CITY OF NEWPORT BEACH
WATERFRONT PROJECT GUIDELINES
AND STANDARDS

HARBOR DESIGN CRITERIA
COMMERCIAL & RESIDENTIAL
FACILITIES

DRAFT, September 1, 2020

SINGLE RESIDENTIAL USE FLOAT WEST NEWPORT CHANNELS

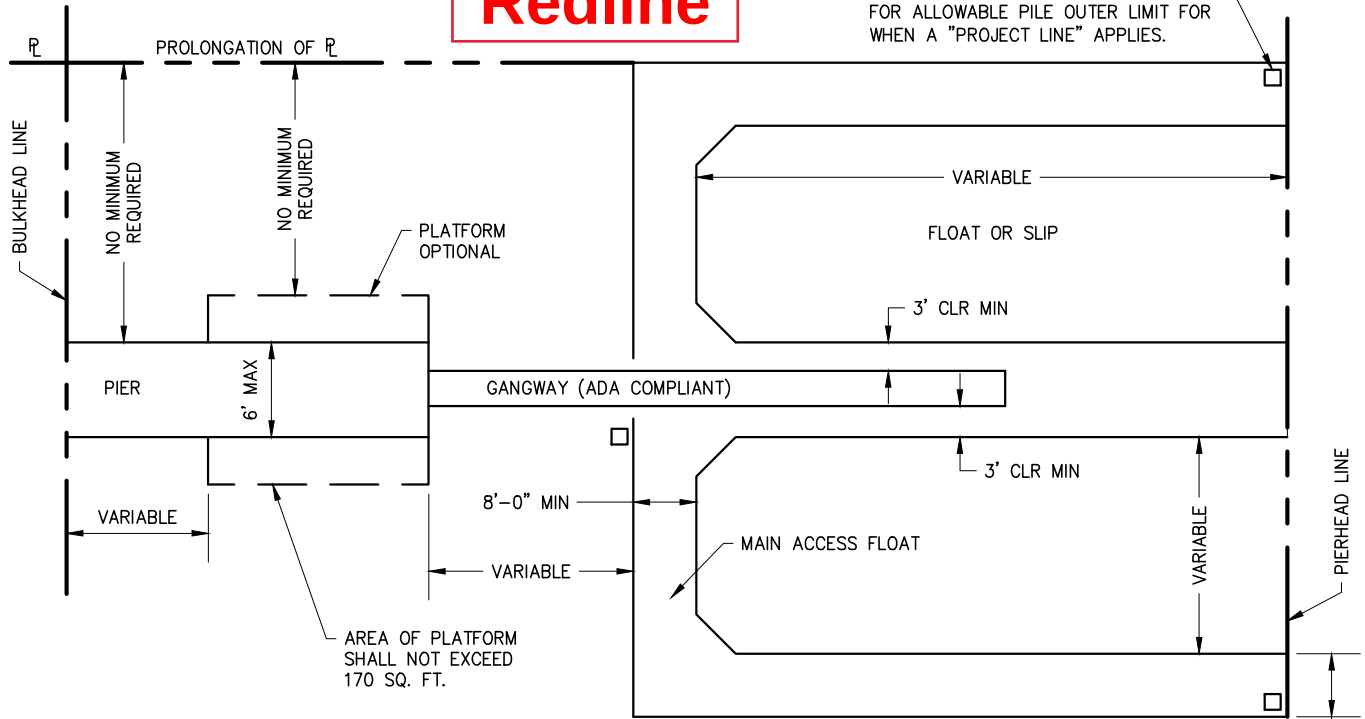
The diagram illustrates a cross-section of a canal structure. On the left, a vertical line represents the **CANAL R/W LINE**. A horizontal dimension line indicates a distance of **18' MINIMUM** from the canal line to the center of a **PILE GUIDE (TYP)**. A red cloud-like shape highlights this area, with a note: **PROLONGATION OF P_L** . Another dimension line shows a **30' MAXIMUM** distance from the pile guide to the right edge of the structure. A horizontal dimension line labeled **VARIES** spans the width of the structure. A vertical dimension line indicates a height of **5' MIN (TYP)** from the bottom of the structure to the top of the pile guide. The structure consists of a **GANGWAY (STD 604)** and a **FLOAT**. The pile guide is shown in two cross-sectional views, one on the gangway and one on the float.
